THE MARYLAND-NATIONAL CAPITAL PARK AND PLANNING COMMISSION

MEMORANDUM

REVIEW TYPE: Mandatory Referral
APPLYING FOR: Modernization of Somerset Elementary School
APPLICANT: Montgomery County Public Schools (MCPS)
CASE NUMBER: 02205-MCPS-1
REVIEW BASIS: Article 28, Section 7-112 of the Annotated Code of Maryland
ZONE: R-60
LOCATION: 5811 Warwick Place, Chevy Chase, Maryland 20815
MASTER PLAN: 1990 Bethesda-Chevy Chase Master Plan
FILING DATE: October 11, 2002
PLANNING BOARD REVIEW: November 21, 2002

Proposed Site Plan

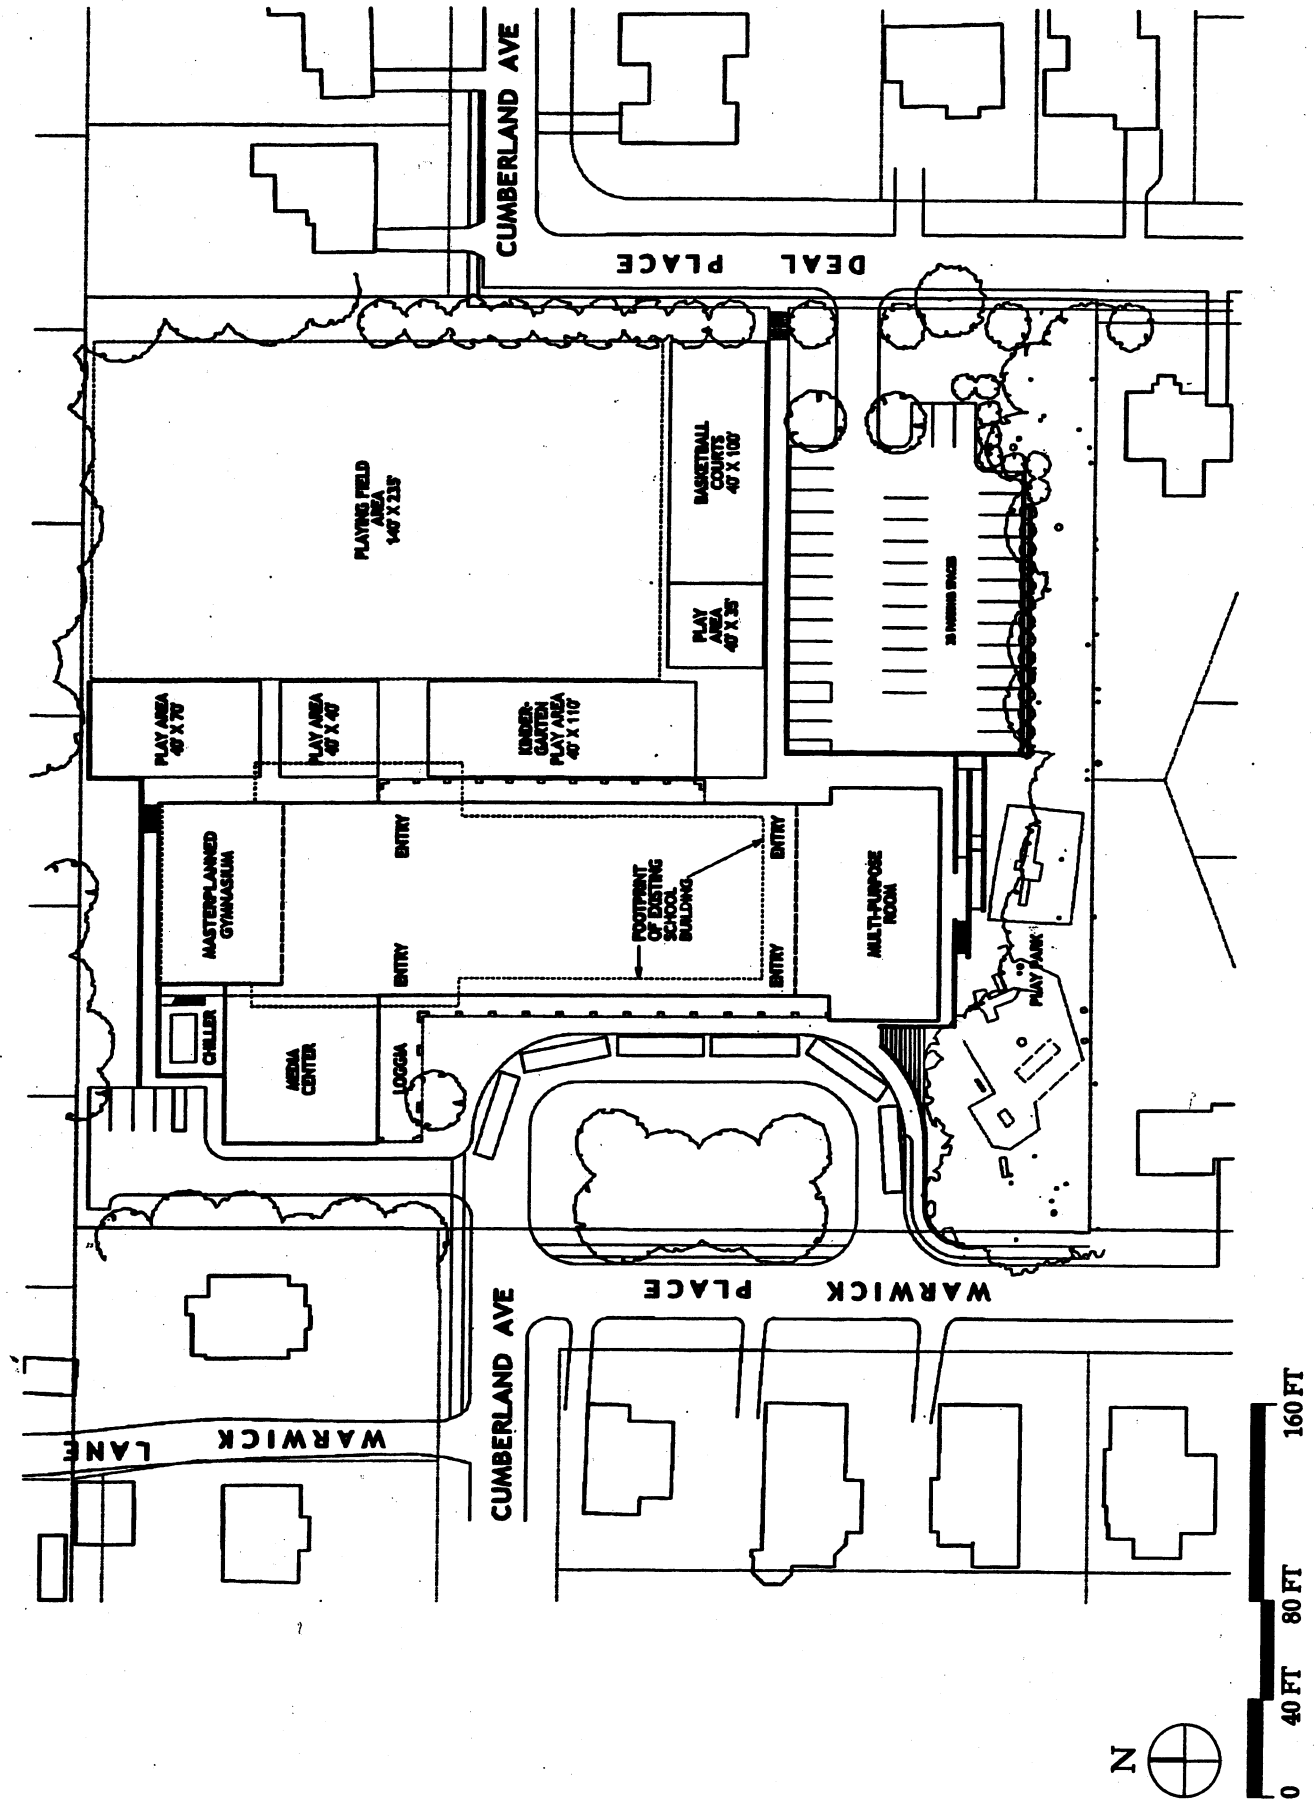
1. A final Tree Save Plan must be approved by the M-NCPPC prior to approval of the sediment and erosion control plan for any clearing, grading or land disturbance of the site;
2. A Storm Water Management Plan approved by the Montgomery County Department of Permitting Services (MCDPS) must be submitted to the M-NCPPC prior to issuance of sediment and erosion control permit;
3. Provide additional protection for trees adjacent to the staff parking lot by shifting three (3) parking spaces and providing porous paving in the southeast portion of the parking lot; and
4. Provide cut-off fixtures at the northeast corner of the site to minimize the light that trespasses into the side and rear yard of adjacent neighbors.

Where significant impacts occur, efforts should be made to minimize the impacts. Consideration shall be given to reducing driveway widths, reconfiguring parking and reducing grading. After disturbance has been minimized, stress reduction measures shall be identified on the plan, as recommended by the arborist. The plan shall identify demolition and construction techniques and schedules, in addition to specifying other appropriate stress reduction measures designed to minimize root destruction and to maximize root re-growth. Tree save measures shall include, but not be limited to, pre-construction watering and fertilizing, fencing, root pruning, and dead wood pruning of any trees impacted by construction activities. Where appropriate the plan should limit the use of heavy construction machinery and specify manual construction. Extraordinary measures such as grid aeration/hydration systems should be examined for specimen trees excessively affected by surrounding imperviousness.
